UNITED STATES PATENT AND TRADEMARK OFFICE

10/773,160

Office Action Summary	Application No.	Applicant(s)	
	10/773,160	COATES, FREDRICA V.	
	Examiner	Art Unit	
	Karin M. Reichle	3761

DETAILED ACTION

FIG. 9.

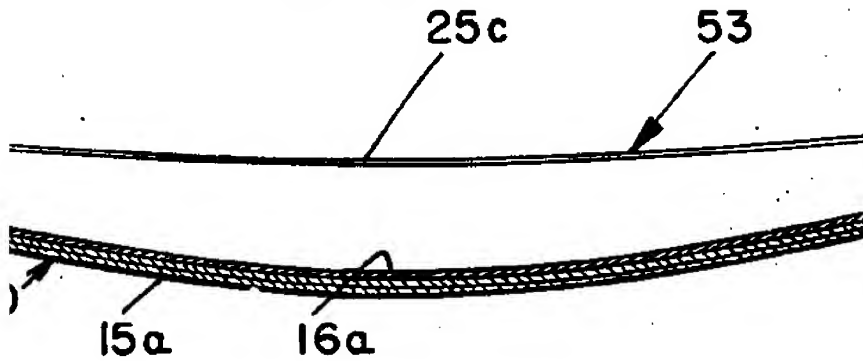
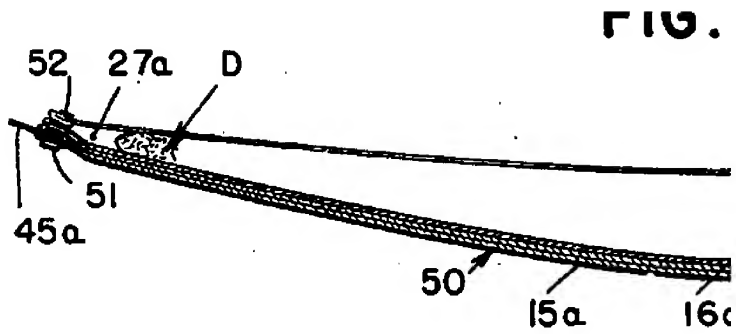
Claims 20 and 21: See Claim Language Interpretation section *supra* hereinafter also referred to as CLI and Figures 7-9, and note the blow-ups of Figure 9 in Appendix A attached to

this action, col. 1, line 55-col. 2, line 6, col. 2, lines 14-31 and col. 3, lines 23-43, i.e. the first part/outer layer is the outer layer of 15a, the first part/anchor layer is the inner layer of 15a, the stitching is 17. The outer layer and anchor layers are separate fabrics layers, the former shaped to conform to a buttock and leg region of the user, see Figures, and the latter having a shape conforming to that of the former. The second part/pocketed sling is 53 which includes four sides and is detachably coupled to the anchor layer but not directly detachably coupled to the outer layer, i.e. only indirectly so coupled, by releasable fasteners which are snap fasteners of two portions 51, 52 located respectively on the anchor layer and sling, see blow up in Appendix A, col. 2, line 7 and col. 3, line 21, elements 20-21 as shown in Figure 2, col. 3, lines 31 and 36-41 and elements 20a, 21a, 50-51 as seen in Figures 7-9. The sling extends from the anchor layer on the inner side of the undergarment when the undergarment is worn to form a pocket for retaining a fluid absorbent pad, i.e. diaper D, facing inwardly away from the anchor layer. The sling is displaced inwardly from corresponding sides toward the center of the anchor layer and inwardly from the stitches between the anchor layer and the outer layer at, e.g., 7b, 7c, 8b, and 8c. It is noted that the entire periphery/all portions of all four sides of the sling is/are still not required to be so inwardly displaced from the entire periphery of the anchor layer, i.e. only the fasteners are, see discussion infra. However also note the position of 31 in Figure 3 and the position of 51 and 52 in Figures 7-9 with regard to stitching 17. The outer layer overlies fasteners on the anchor layer, e.g. 20a, 21a, 50 and/or 52. Claim 20 now requires the outer layer completely overlying the releasable fasteners. While the outer layer overlies a portion of the fasteners 51, 20a, 21a which are on the inside thereof and fasteners 52 when the garment is unfastened and overlies completely some fasteners, e.g. 20a, when the garment is fastened, see Figure 1, such layer does
